BCA ASSESSMENT REPORT

Aspect Industrial Estate
Mamre Road, KEMPS CREEK

PREPARED FOR:
Mirvac

Revision 3

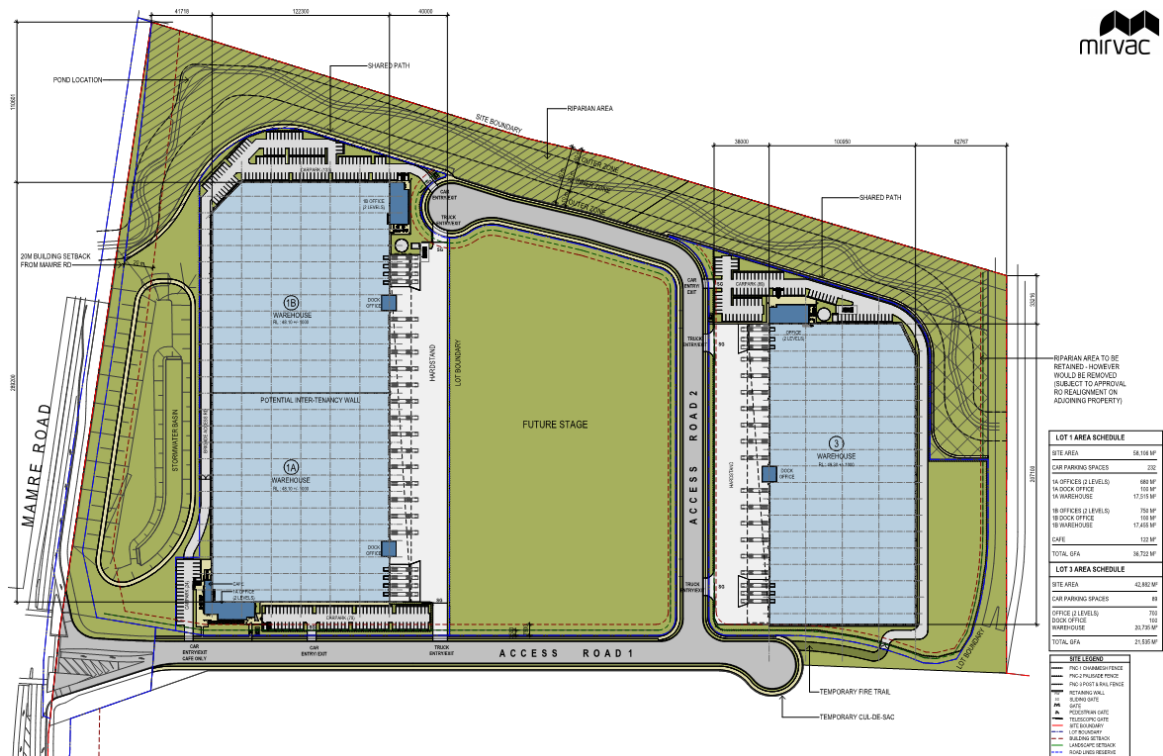
Comments: The proposed warehouse buildings do not comply with the provisions of C2.4 in the following areas which will need to be addressed as a Performance Solution from the Fire Engineer to demonstrate compliance with Performance Requirement CP9:

- + *The furthest part of the vehicular access path is greater than 18m from the external wall at the northern and southern portions of each building (see diagram below).*
- + *Portions of the vehicular perimeter access will be provided via adjacent lots.*
